**MICROCHIP****dsPIC30F6011/6012/6013/6014**

dsPIC30F6011/6012/6013/6014 Family Silicon Errata and Data Sheet Clarification

The dsPIC30F6011/6012/6013/6014 family devices that you have received conform functionally to the current Device Data Sheet (DS70117F), except for the anomalies described in this document.

FIGURE 1: DCI SLAVE WORK AROUND

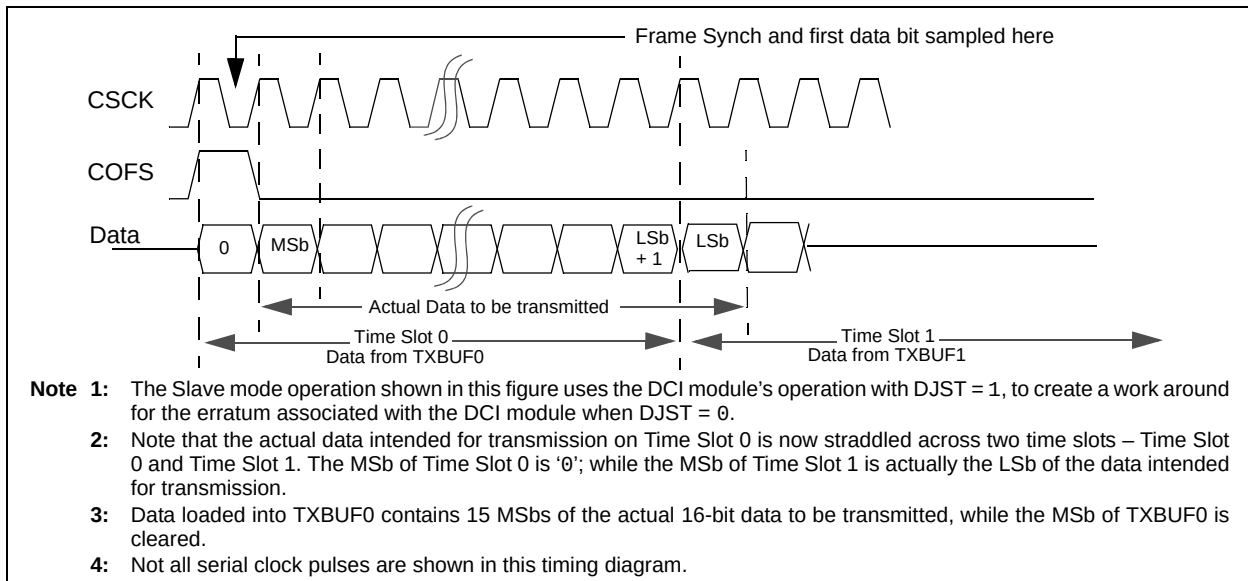
The Data Converter Interface (DCI) module does not function correctly in Slave mode when the following conditions are true:

- The DCI module is configured to transmit/receive one serial clock (bit clock) after the frame synchronization pulse, DJST (DCICON1<5>) = 0.
- The frame length chosen is longer than 1 word, COFSG<3:0> (DCICON2<8:5>) > '0000'.

1. Set the DJST bit to '1'.
2. Enable an additional time slot immediately following each time slot intended for communication.
3. Enable an additional transmit/receive buffer word (modify COFSG bits) or an additional bit per word (modify WS) for each time slot intended for communication.
4. Shift the data word by 1-bit to the right and load the transmit buffer word(s), such that the Least Significant bit of the original data word to be transmitted is loaded into the additionally enabled bit of the Transmit Buffer register, TXBUF_n, or the Most Significant bit (MSb) of the additionally enabled transmit buffer, TXBUF_n + 1.

Assume, the application needs the DCI module to act as a Slave transmitting 1 serial clock after the frame synchronization pulse is received. Further, assume that the application needs to transmit 16-bit data word on Time Slot 0 and the communication is over a 256*Fs channel. In order to reduce interrupt frequency, we enable all 4 transmit buffers. The DCI module SFRs should be initialized as follows before being enabled:

- DCICON1 = 0x0720, DCICON2 = 0x0DEF
DCICON3 = 0x0000,
TSCON = RSCON = 0x0003

An example of loading the DCI transmit buffers for the configuration above is shown in Example 11. A timing diagram in Figure 1 illustrates the various signals for this example. A similar rule may be applied to reading the received data from the RXBUF_n SFRs.
